ISSUED: 11-29-1922
REISSUED: 2-17-1953-B E.W.
" : 10-15-1957-C FLA

PENNSYLVANIA SYSTEM
FREIGHT CARS & TENDERS
TRUCKS
CROWN S. C. SIDE FRAME

C 71197 C

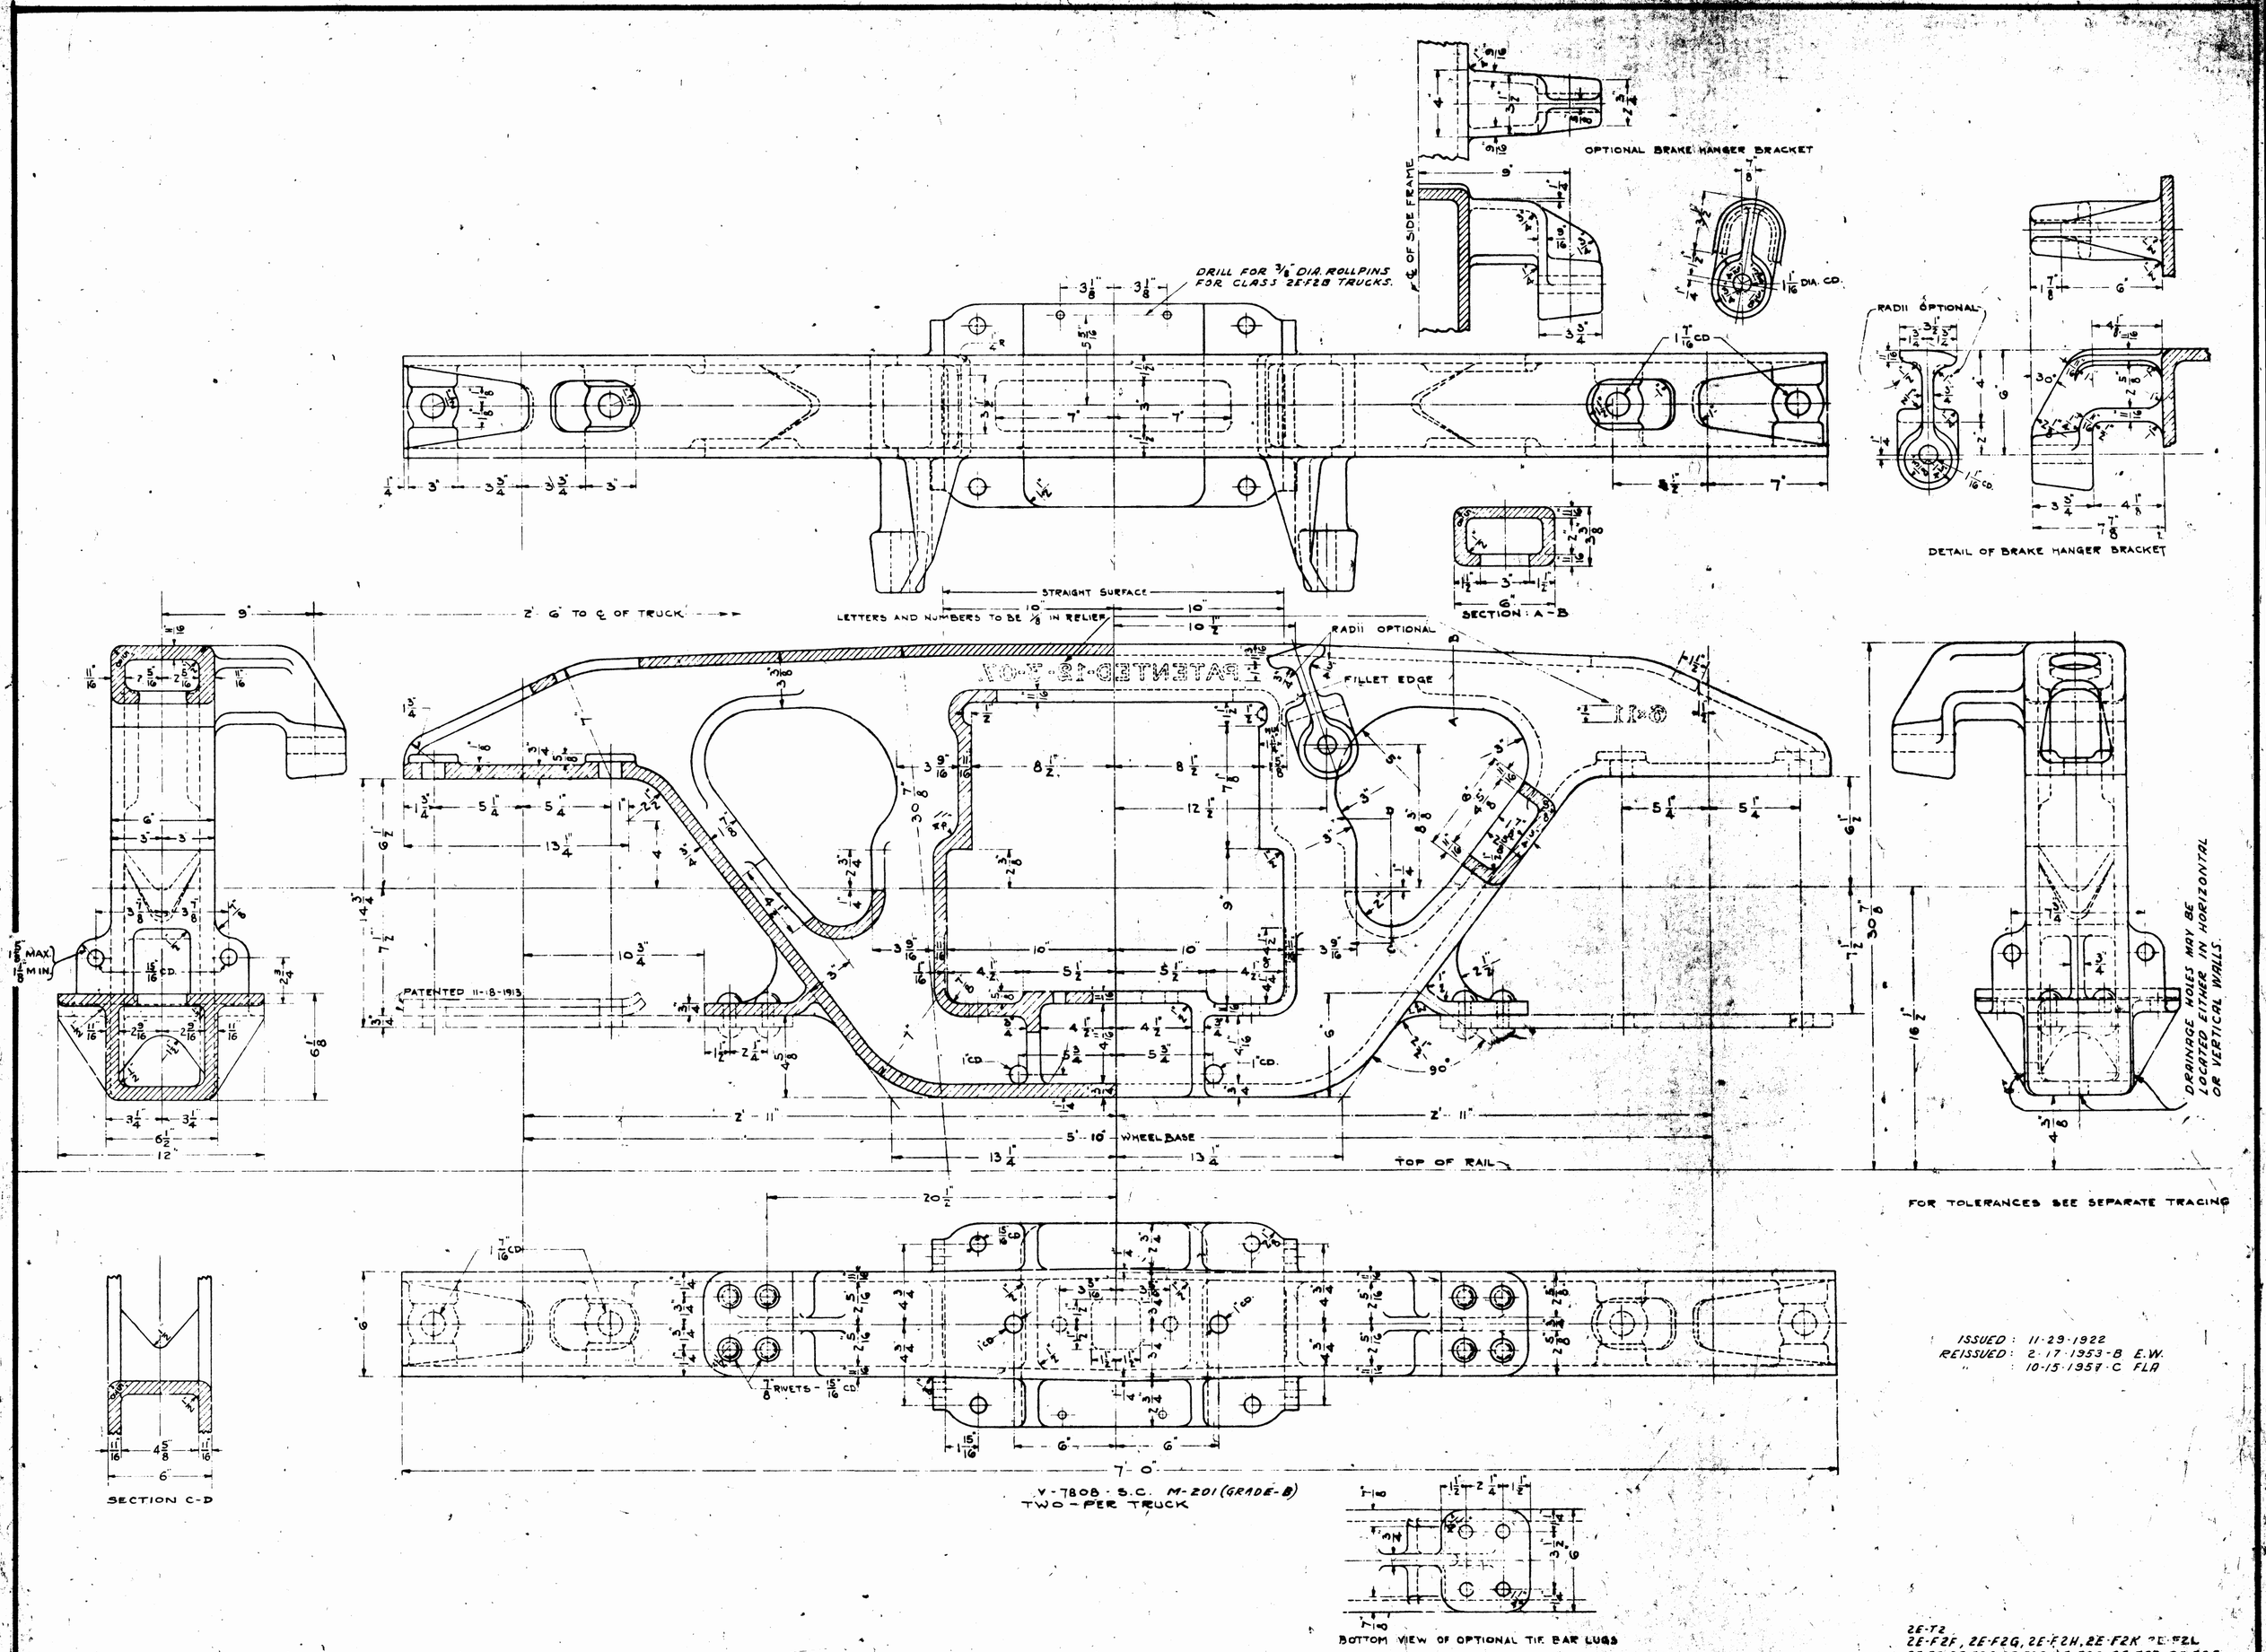
HOLES FOR 3/8" DIA. ROLLPINS ADDED IN SPRING SEAT FLANGE FOR CLASS 2E-F2B TRUCKS & HOLES REFERRED TO IN "B" REISSUE NOTE DATED 2-17-53 REMOVED ON ACCOUNT OF NEVER BEING USED. 10-15-57

HOLES 3/8" DIA IN SPRING SEAT FOR USE WITH 2-ST FRICTION SPRING GROUP, SHOWN. 2-17-1953
